Change to Carrier Tape for XLamp® XB-D, XT-E & XP-G2 LEDs

PCN-CM029

Announcement Date: September 17, 2012

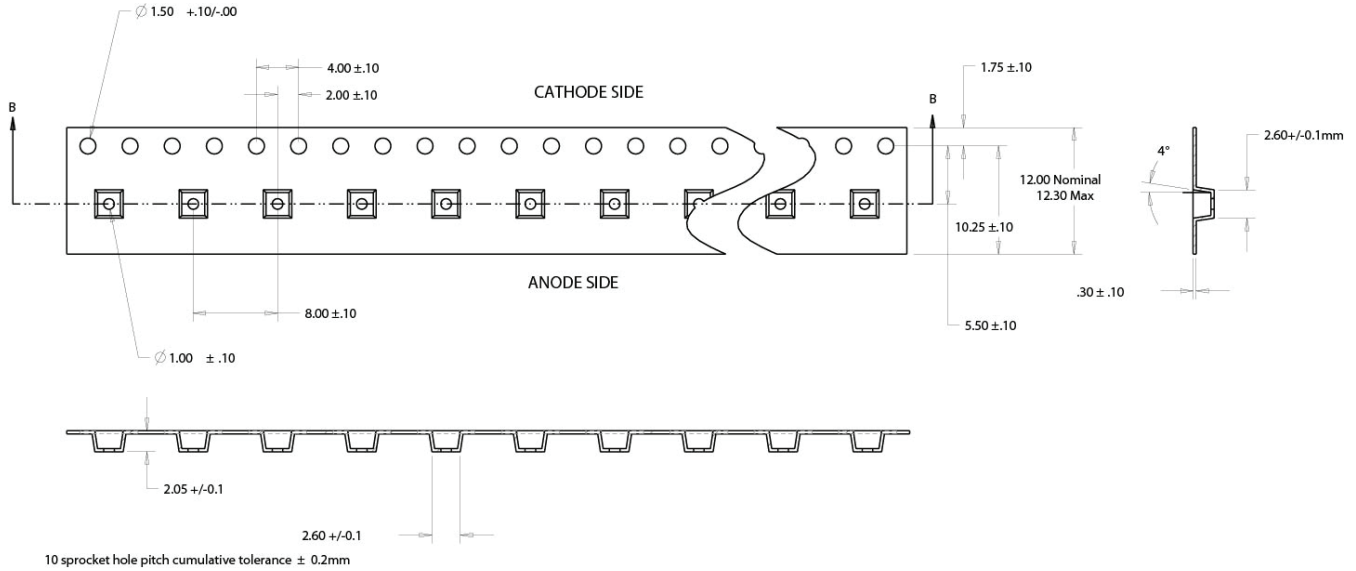
Cree will begin shipment of XLamp XB-D, XT-E & XP-G2 LEDs with a modified carrier tape. This change will improve the pick-and-place performance for these LEDs. The quantity of LEDs on a reel remains unchanged. The new carrier tape dimensions are shown on the next page.
